**Monks Orchard Residents'
Association
Planning**

Reference: 21/06036/FUL
Application Received: Fri 03 Dec 2021
Application Validated: Fri 03 Dec 2021
Address: Land R/O Firsby Avenue & Verdayne Avenue, CR0 8TL
Proposal: Erection of nine semi-detached and terraced houses, together with associated access, car parking and landscaping.
Status: Awaiting decision
Consultation Expiry Date: Sun 02 Jan 2022
Determination Deadline: Fri 28 Jan 2022
Case Officer: Neil McClellan

Please accept this letter as a formal response to **Application Ref: 21/06036/FUL** for Erection of nine semi-detached and terraced houses, together with associated access, car parking and landscaping at Land R/O Firsby Avenue and Verdayne Avenue.

Assessment of proposal Residential Density in relation to Setting and PTAL

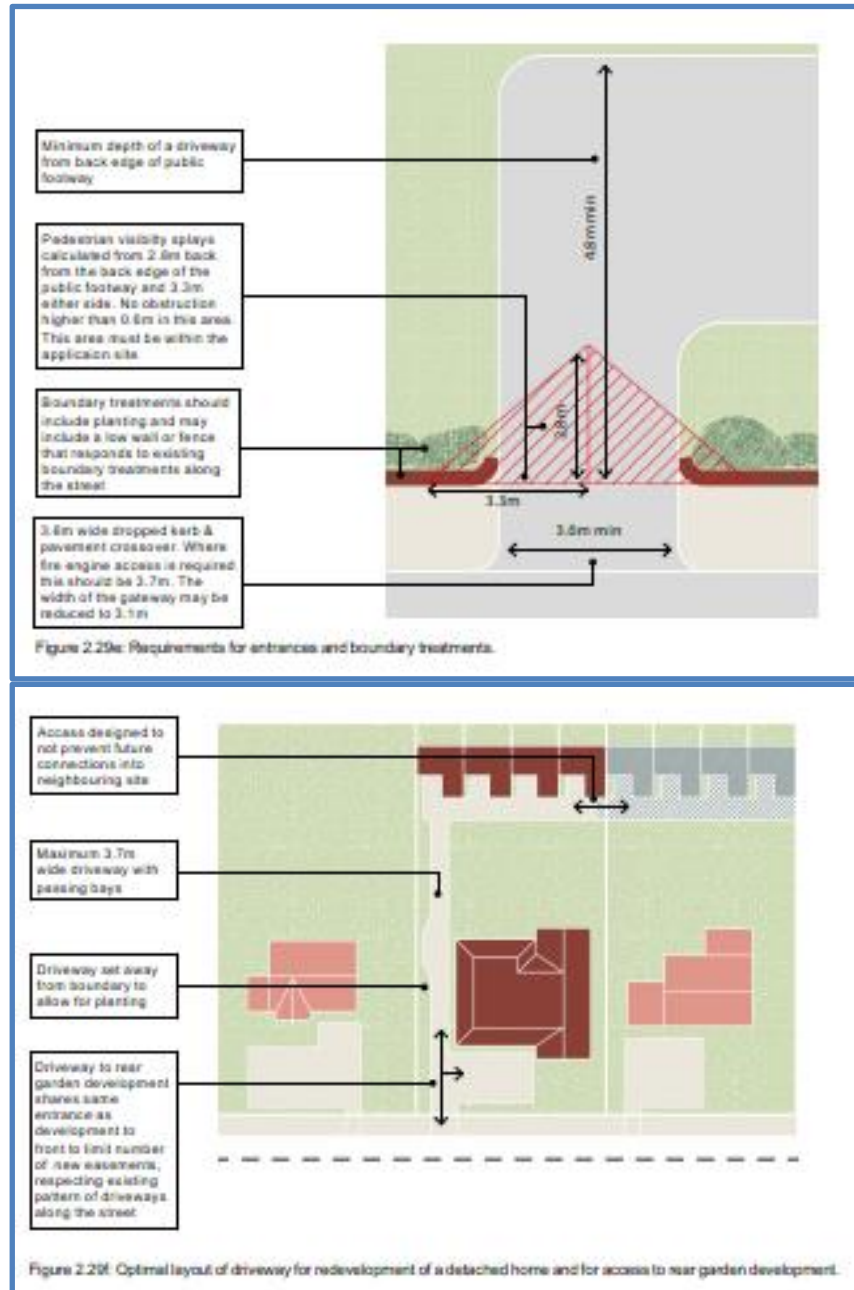
- 2.3.4 The **Residential Density** analysis shows that the required **PTAL** to support a proposed **Residential Density** of **241.67 hr/ha** would be:
 $241.67 = 33.33 \cdot x + 150$ therefore $x = \text{PTAL} = \mathbf{2.75}$ or,
Residential Density of **220.83 bedspaces/ha** would be:
 $220.83 = 33.33 \cdot x + 150$ therefor $x = \text{PTAL} = \mathbf{2.1}$.

- Thus, we believe this is probably within an acceptable tolerance from the available **PTAL** of **2** at this location. This assumption is based upon the **ONS** and **Statista** Data of **National Occupancy per Dwelling**.
